P r o p o s a l f r o m S p a i n f o r  
V e h i c l e T y p e A p p r o v a l  
C h a r g i n g M o d e s 2 a n d 3

Submitted by the experts from the Spain to the  
GRE IWG-EMC- 39th Session

Friday, 15<sup>th</sup> September, 2023

## ANNEXES 11, 12, 13, 15 AND 16

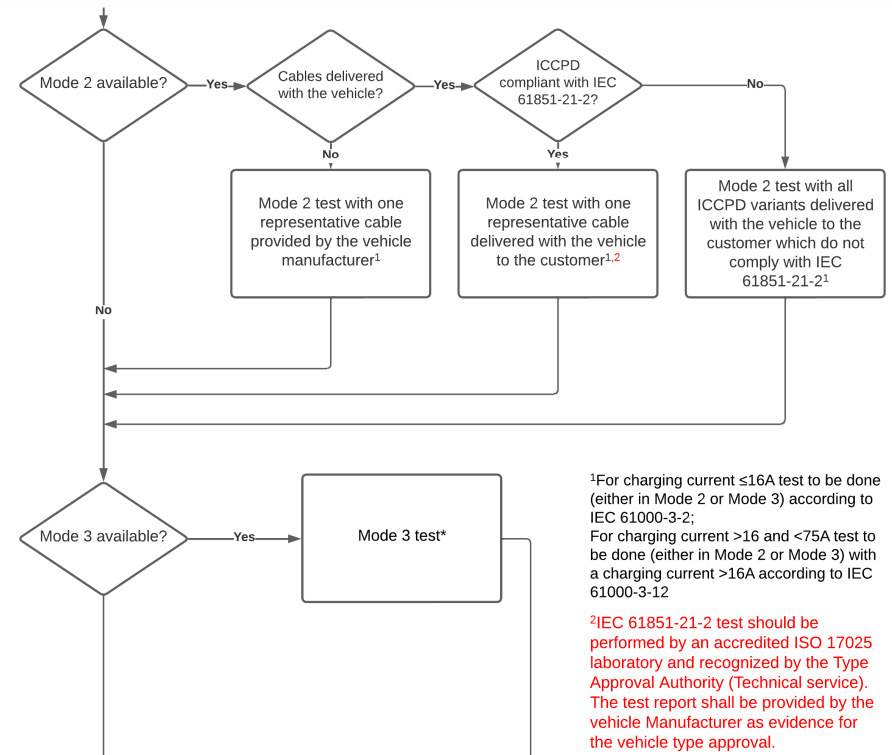
- Spain main concern is due to the test experience with **Annexes 11, 12, 13, 15 and 16** with different results (OK/NOK) in REESS charging Mode 2 with ICCPD cables certified IEC 61851-21-2.
- If **ICCPD cable/s delivered with the vehicle and IEC 61851-21-2 compliant**, Spain agree to test Mode 2 with one representative cable delivered with the vehicle to the customer but,

*IEC 61851-21-2 test should be performed by an accredited ISO 17025 laboratory and recognized by the Type Approval Authority (Technical service). The test report shall be provided by the vehicle Manufacturer as evidence for the vehicle type approval.*

# MODE 2 ANNEX 13

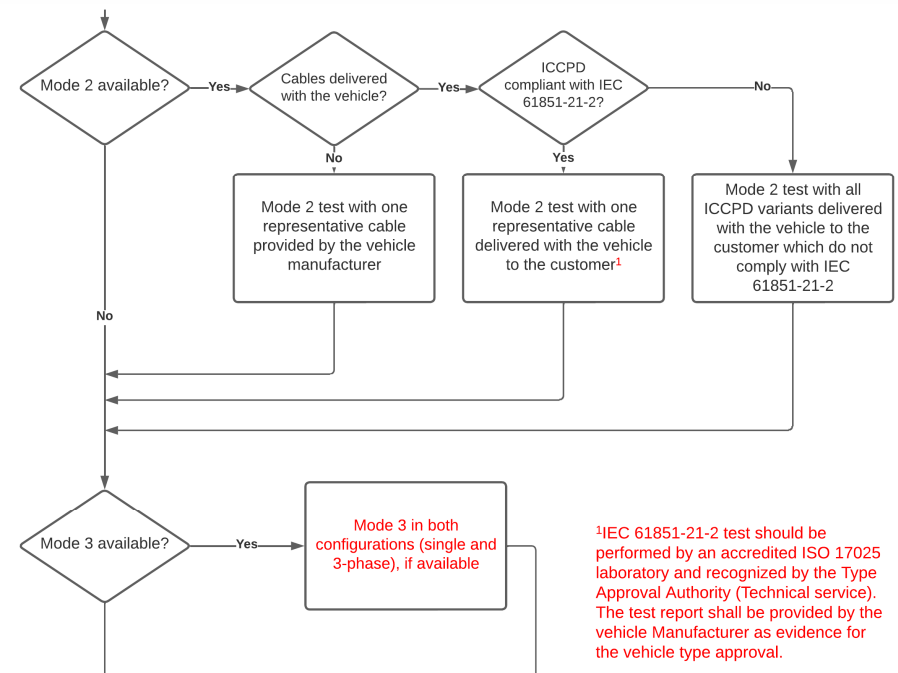
- Spain main concern is due to the test experience with [Annex 13](#) with different results (OK/NOK) in REESS charging Mode 3 because other vehicle components not related to REESS could affect to the result of conducted emissions depending on the charge mode in single-phase or three-phase.
- Both **single-phase and three-phase should always be considered** for testing in Mode 3 (if vehicle manufacturer declare both types of connection).
